**SUBJECT:** **R.E. Ginna Nuclear Power Plant**  
Docket No. 50-244

License Amendment Request: Spent Fuel Pool Storage Capacity

**Proposed Technical Specification Changes (Mark-up)**

Figure 3.7.13-7  
Burnup Vs Enrichment Curves for Region 2 Type 2 and Type 4 Cells (No Pu-241 Decay)

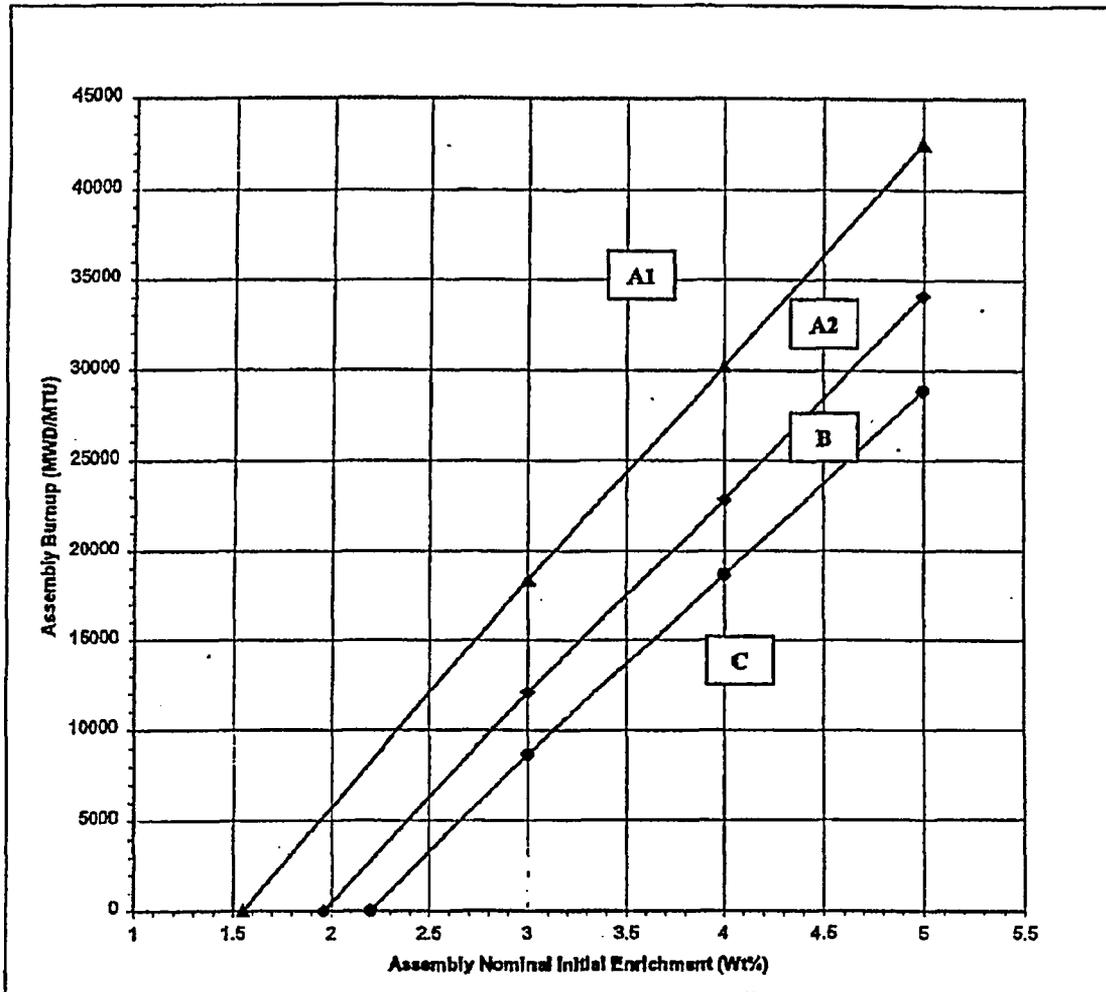
The specification for 1369 storage locations is based on allowing Ginna to install the additional wall mounted Type 4 module racks at a later time. Ginna no longer believes that installing these additional wall mounted racks is a storage option that will be implemented. Therefore, the maximum number of fuel assemblies that would be stored in the existing Ginna SFP after EPU will be limited to the 1321 existing storage locations and the reference to Type 4 racks will be removed.

- A1 Acceptable burnup domain for storage in any location within Region 2 Type 2 and Type 4 Cells
- A2 Acceptable burnup domain for storage face-adjacent to a Type A1 or A2 assembly, or a water cell within Region 2 Type 2 and Type 4 Cells
- B Acceptable burnup domain for storage face-adjacent to a Type A1 assembly, or a water cell within Region 2 Type 2 and Type 4 Cells
- C Acceptable burnup domain for storage face-adjacent to a water cell only, within Region 2 Type 2 and Type 4 Cells

Figure 3.7.13-8  
Burnup Vs Enrichment Curves for Region 2 Type 2 ~~and Type 4~~ Cells (5-Year Pu-241 Decay)

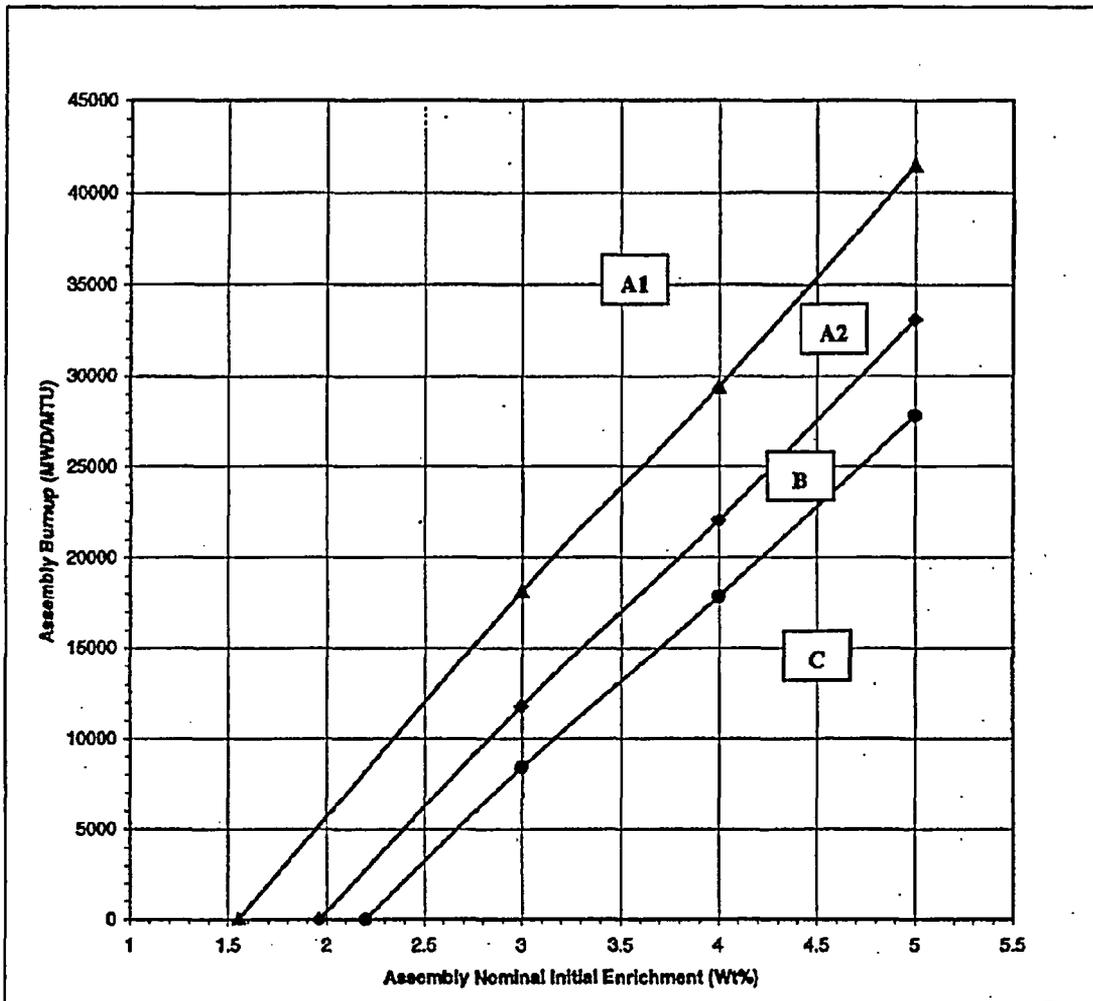
- A1** Acceptable burnup domain for storage in any location within Region 2 Type 2 ~~and Type 4~~ Cells
- A2** Acceptable burnup domain for storage face-adjacent to a Type A1 or A2 assembly, or a water cell within Region 2 Type 2 ~~and Type 4~~ Cells
- B** Acceptable burnup domain for storage face-adjacent to a Type A1 assembly, or a water cell within Region 2 Type 2 ~~and Type 4~~ Cells
- C** Acceptable burnup domain for storage face-adjacent to a water cell only, within Region 2 Type 2 ~~and Type 4~~ Cells

Figure 3.7.13-9  
Burnup Vs Enrichment Curves for Region 2 Type 2 and Type 4 Cells (10-Year Pu-241 Decay)

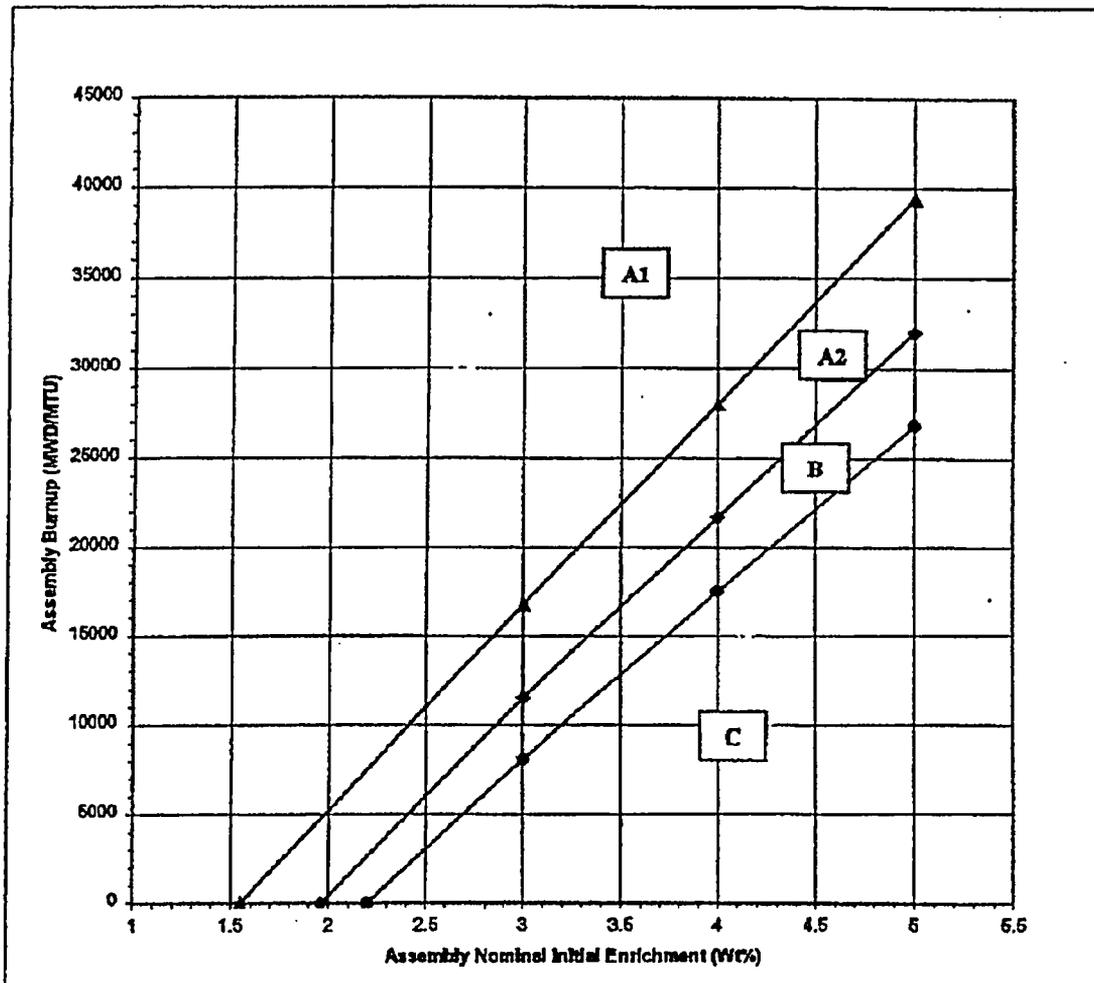
- A1** Acceptable burnup domain for storage in any location within Region 2 Type 2 and Type 4 Cells
- A2** Acceptable burnup domain for storage face-adjacent to a Type A1 or A2 assembly, or a water cell within Region 2 Type 2 and Type 4 Cells
- B** Acceptable burnup domain for storage face-adjacent to a Type A1 assembly, or a water cell within Region 2 Type 2 and Type 4 Cells
- C** Acceptable burnup domain for storage face-adjacent to a water cell only, within Region 2 Type 2 and Type 4 Cells

Figure 3.7.13-10  
Burnup Vs Enrichment Curves for Region 2 Type 2 ~~and Type 4~~ Cells (15-Year Pu-241 Decay)

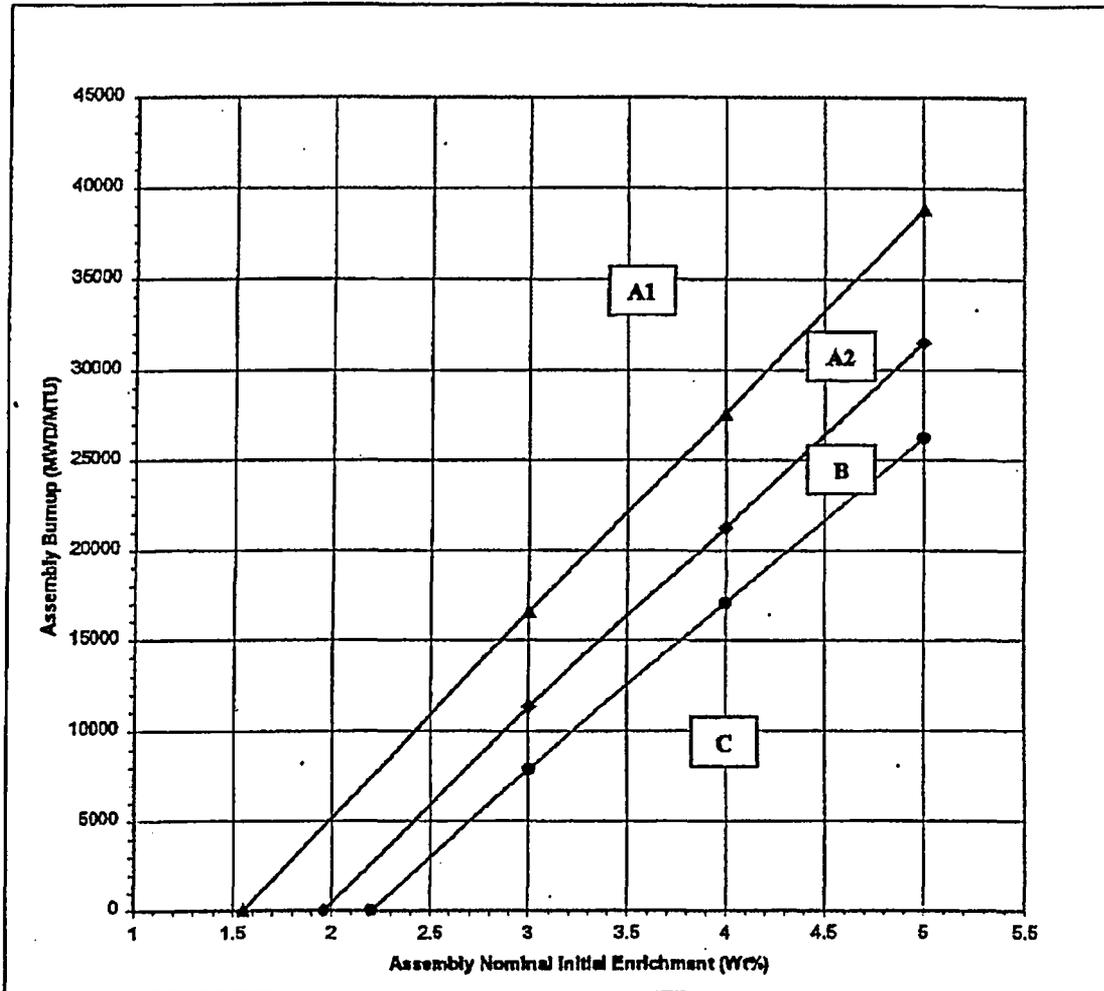
- A1 Acceptable burnup domain for storage in any location within Region 2 Type 2 ~~and Type 4~~ Cells
- A2 Acceptable burnup domain for storage face-adjacent to a Type A1 or A2 assembly, or a water cell within Region 2 Type 2 ~~and Type 4~~ Cells
- B Acceptable burnup domain for storage face-adjacent to a Type A1 assembly, or a water cell within Region 2 Type 2 ~~and Type 4~~ Cells
- C Acceptable burnup domain for storage face-adjacent to a water cell only, within Region 2 Type 2 ~~and Type 4~~ Cells
